Certificate of Appropriateness Case Report

HEARING DATE: MARCH 16, 2011

Filing Date: December 16, 2010
Case No.: **2010.1139A**
Project Address: **1067 TENNESSEE STREET**
Historic Landmark: Dogpatch Historic District
Zoning: RH-3 Zoning District
40-X Height and Bulk District
Block/Lot: 4108/010
Applicant: Reza Khoshnevisan
Sia Consulting Corporation
1256 Howard Street
San Francisco, CA 94103
Staff Contact Richard Sucre - (415) 575-9108
richard.sucre@sfgov.org
Reviewed By Timothy Frye - (415) 575-6822
tim.frye@sfgov.org

A-3.0

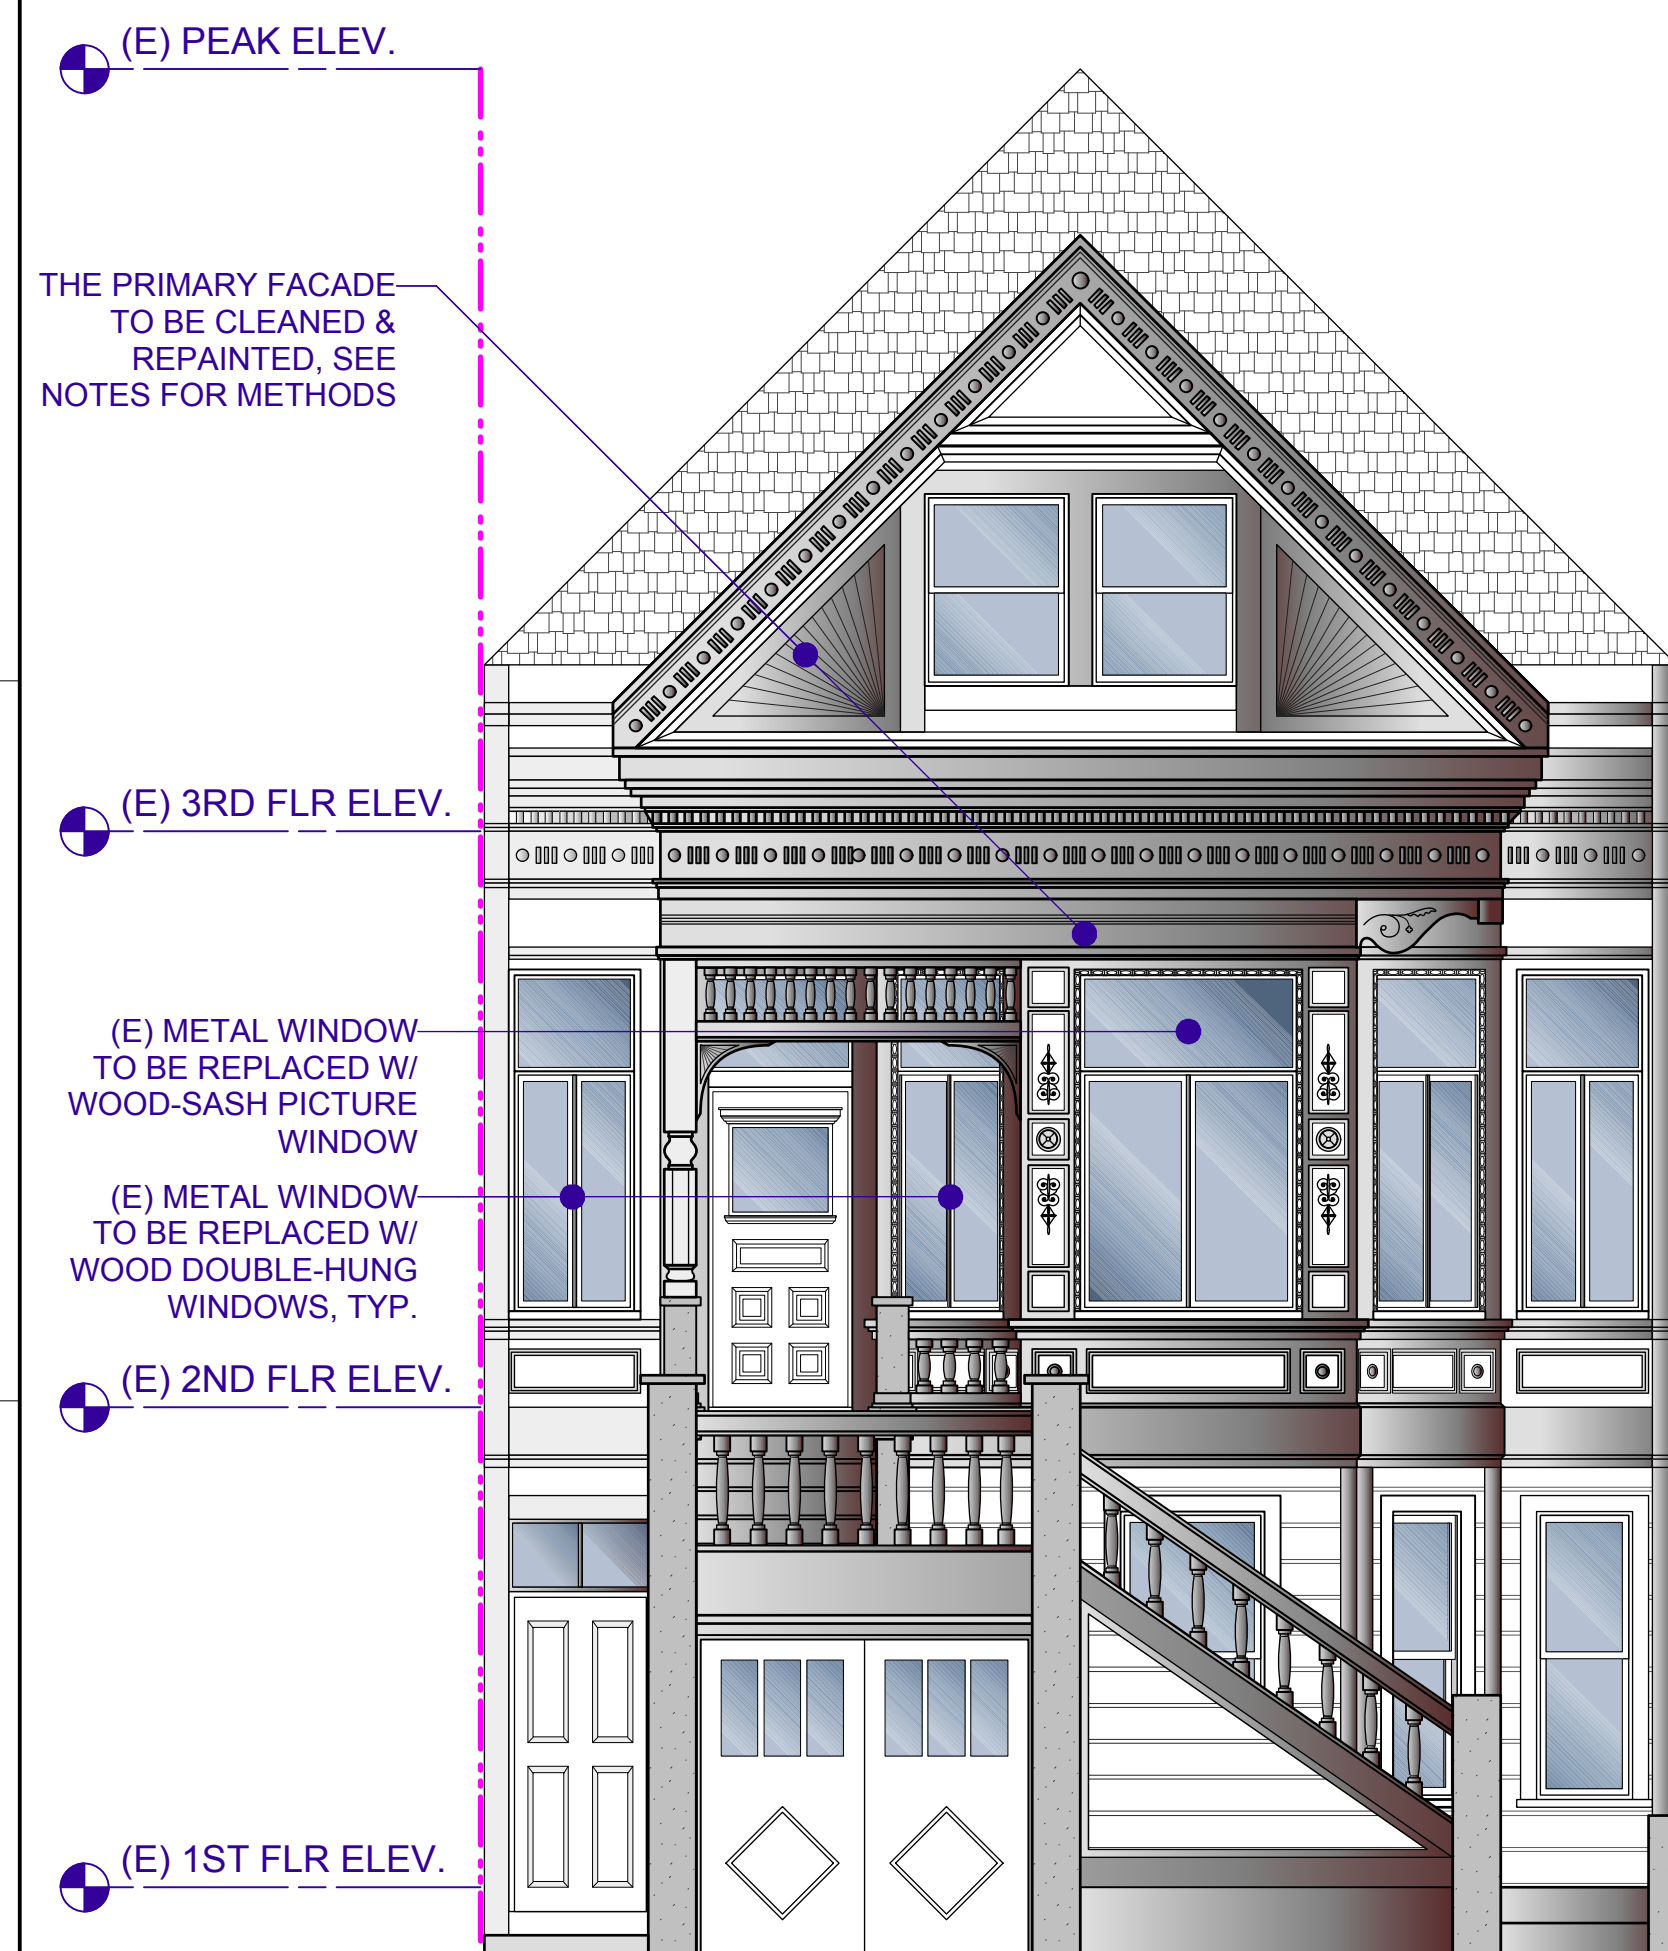
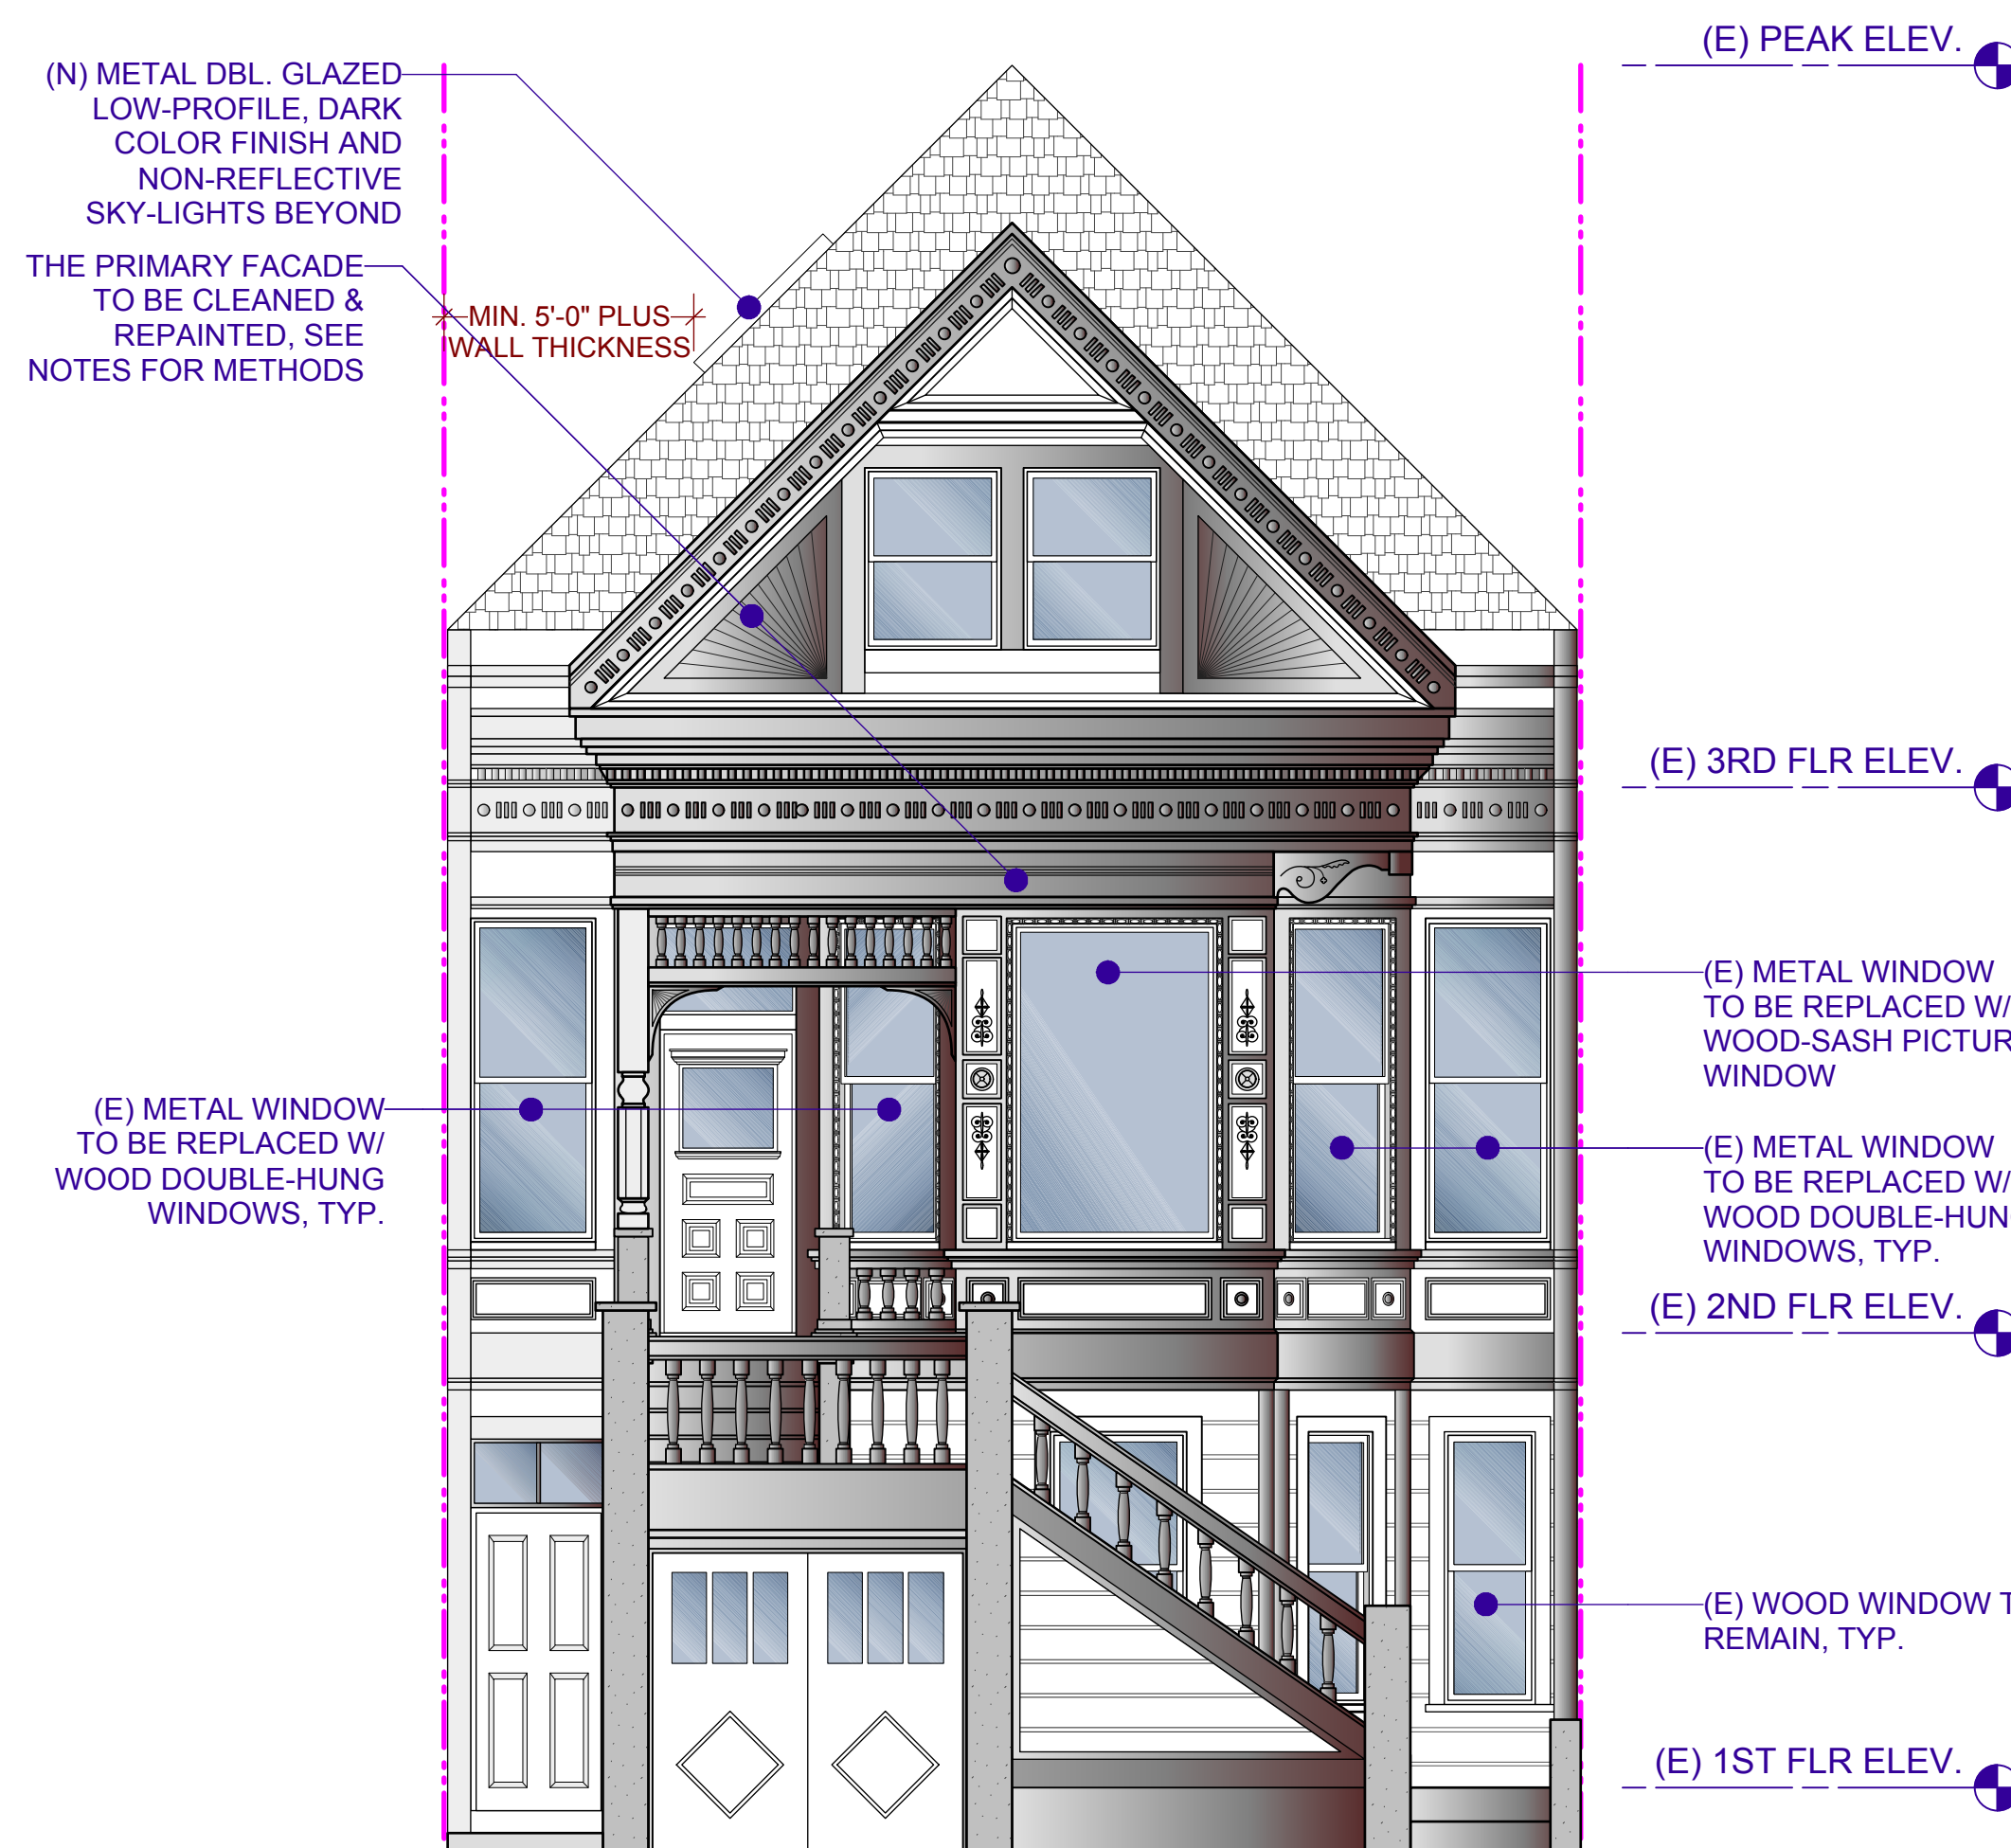
Primary Façade Alterations: The existing façade is covered in a sprayed-on “gunnite-like” substance, which appears to be a textured paint, and currently features metal-sash slider windows on the second floor. The proposed project will clean and repaint the primary façade facing Tennessee Street, and will replace the existing metal-sash windows with wood-sash double-hung windows.

The replacement of the wood-sash windows on the second floor will assist in bolstering the historic integrity of the subject property, and is a compatible alteration that will not affect the character of the surrounding historic district. Wood-sash double-hung windows are commonly found on historic residential properties in the Dogpatch Historic District.

As specified on the architectural drawings, the exterior treatment will remove paint and dirt using the “gentlest means possible,” which has been defined as:

This treatment appears to be appropriate. To ensure that the work is completed accordingly, Planning Department Preservation staff will review a sample of this treatment to ensure that the existing paint is being removed using “gentlest means possible.” This treatment will not adversely impact the building’s historic fabric, and will assist in improving the current condition of the property.

Rear Façade Alterations: The proposed project includes alterations to the rear façade that consist of: the removal of all existing rear windows, rear doors, and rear stairs; installation of new windows on all levels; installation of new glazed patio doors on the ground and second floors; installation of one rear staircase; and construction of a roof deck on the third floor. The rear façade is not visible from the public right of way, and does not possess any significant character-defining features (other than the historic massing), which contribute to the Dogpatch Historic District. Therefore, alterations to the windows and doors on this façade and the installation of a new rear staircase will not adversely impact the historic character of the subject property or surrounding historic district. To ensure compatibility with adjacent properties, the proposed project will retain the horizontal rustic wood siding, which is found throughout the historic district. The new windows and doors are styled in a contemporary manner. No exterior additions are planned on the rear façade and the building will retain its characteristic Queen Anne detailing. Overall, the rear façade alterations do not impact the surrounding historic district or the historic status of the subject property.

1. As part of the Building Permit, a sampling of cleaning and repainting of the exterior street façade shall be reviewed by Planning Department Preservation staff prior to initiation. This sampling should occur in a discrete, minimally-visible location and should test all cleaning solvents and

solutions to be used in removing the existing paint from the exterior façade. Staff shall approve of the proposed treatment if deemed to be the “gentlest means possible.”
